July 20, 2026

Re: July 22 Hearing Officer Public Hearing
ITEM 3: 7354 ROMERO DRIVE - VARIANCE and COASTAL DEVELOPMENT PERMIT
PRJ-1101825

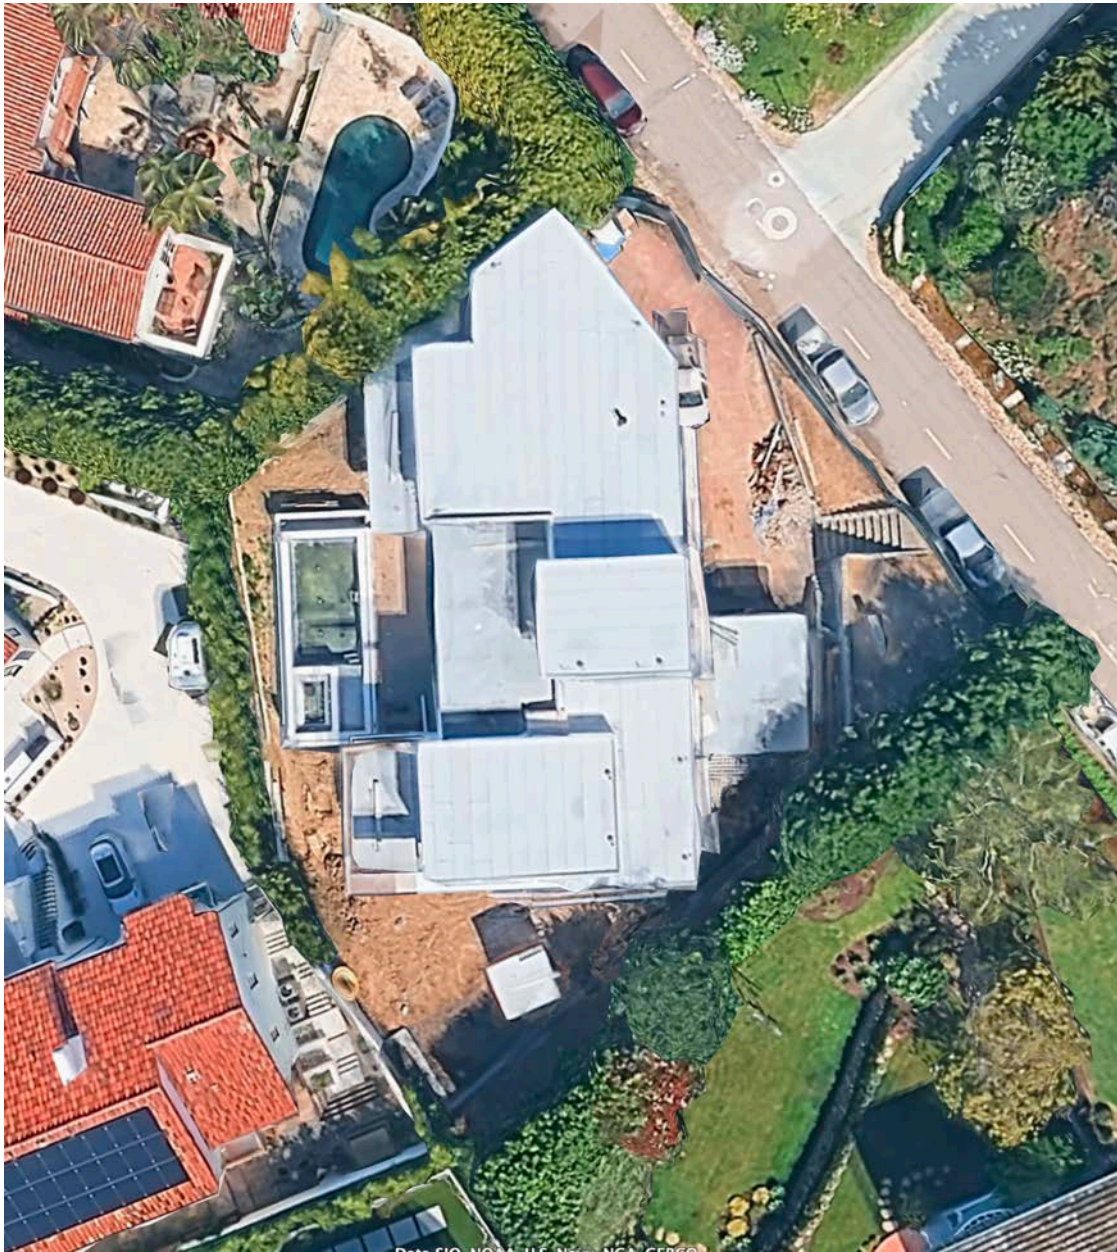
Using my Archicad software, the *gross floor area* of each of the three floor levels is depicted on the attached *Gross Floor Area Diagram*. The total *gross floor area* of the proposed structure is:

Third Floor	243.80 sq. ft.
Second Floor	3,229.09 sq. ft.
First Floor	3,319.18 sq. ft. (<u>excluding</u> the area of the ADU)
Total Gross Floor Area	6,792.07 sq. ft.

The *Gross Floor Area* of 6,792.07 sq. ft. divided by the Lot Area of 12,955 sq. ft. equates to a Floor Area Ratio (FAR) of 0.524, where a FAR of **0.52** (6,736.6 sq. ft.) is the maximum allowed in the RS-1-4 Zone.

The proposed project with a Total Gross Floor Area of 6,792.07 gross square feet exceeds the maximum allowed Gross Floor Area of 6,736.6 sq. ft. by **55.47 sq. ft.**

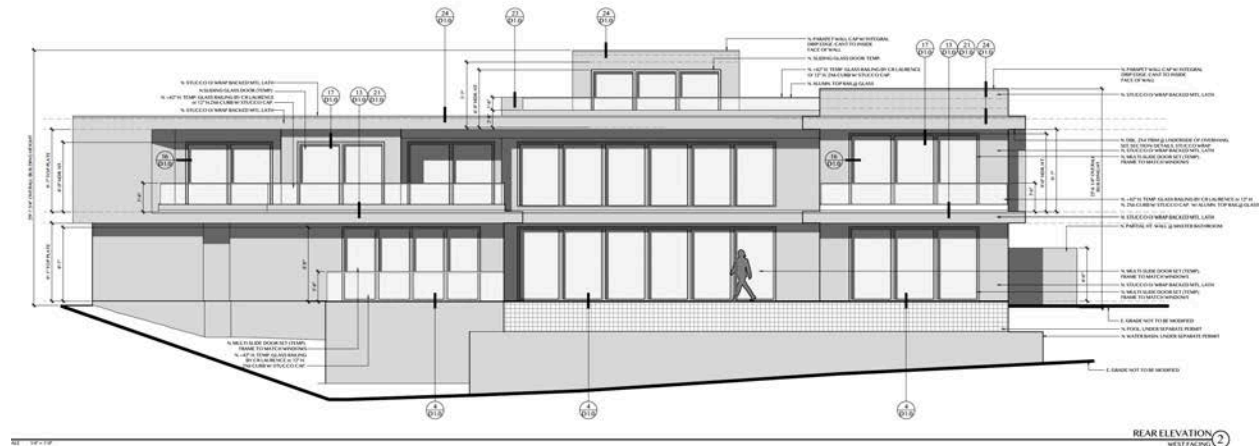
The Building Department approved construction drawings (Sht. No. A3.0) depicted on the following page shows the existing adjacent grade level at the swimming pool being slightly more than 10 feet below the existing main floor level and existing grade level at the front of the house. The maximum allowed Overall Structure Height for this project on the sloping lot is 30 feet plus a grade differential of 10 feet equals 40 feet. The lowest point of the dark grade line on the REAR ELEVATION (A3.0) is shown to be 40 feet below the high point of the roof.

But as clearly stated in Comment No. 88, of the DSD's Final Issues Report PRJ-1101825 Overall Structure Height is measured from the lowest point of grade within 5 feet of the structure. Because the existing grade slopes downhill and away from the swimming pool, the lowest point of grade within 5 feet of the structure is significantly lower than the dark grade line on the REAR ELEVATION drawing (A3.0). As such, the existing structure is more the 40 feet in Overall Structure Height and exceeds the maximum allowed Overall Structure Height.

The photographs on the following page clearly show the existing grade level at the near south end of the swimming pool is significantly different from and lower than that depicted in the REAR ELEVATION drawing (A3.0).

THIRD FLOOR LEVEL - GROSS FLOOR AREA 243.80 sq ft

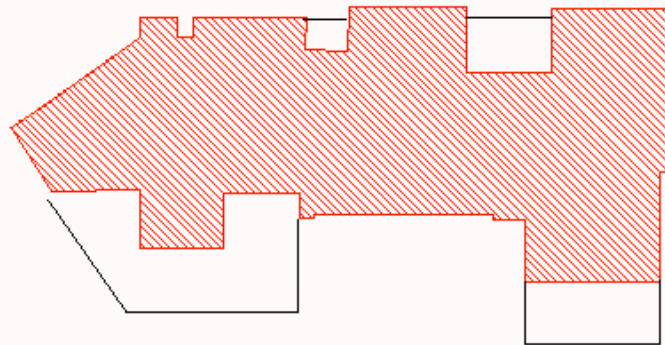
The cross hatched areas on the architect’s floor area diagram on Sht. No. A6.0 are within the exterior surface of the surrounding exterior walls of the building, and therefore **must** be included in the *Gross Floor Area of the structure*. The architect’s floor area diagrams omit the *gross floor area* on the third floor level.
